# Access Compliance Report

## Public Rights-of-Way

### (Curb Ramps)

Intersection ID: N/A	Main Street: ARROW PINE DR	Cross Street: N/A	Location: S
ADA ID: 8B3673AD8D6C	Ramp Type: Perp	Initial Pass/Fail: Pass	Overall Compliance: No
		Severity Score: 15

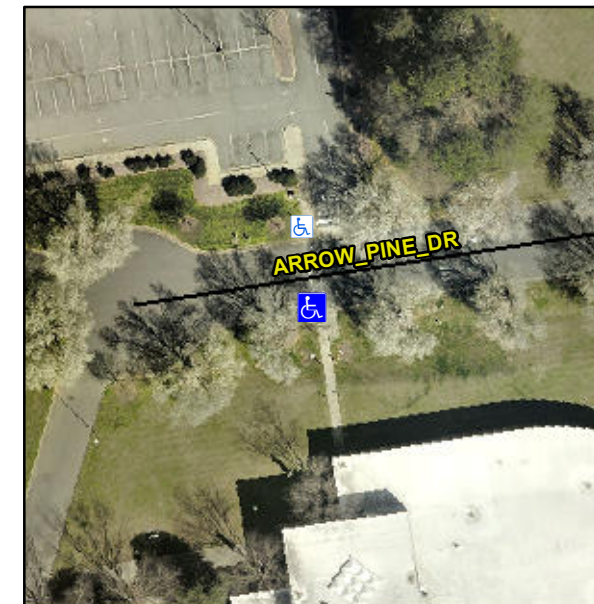
**R305, R304.5.4**

**Install Detectable Warning System.  
Remove & Replace Gutter.**
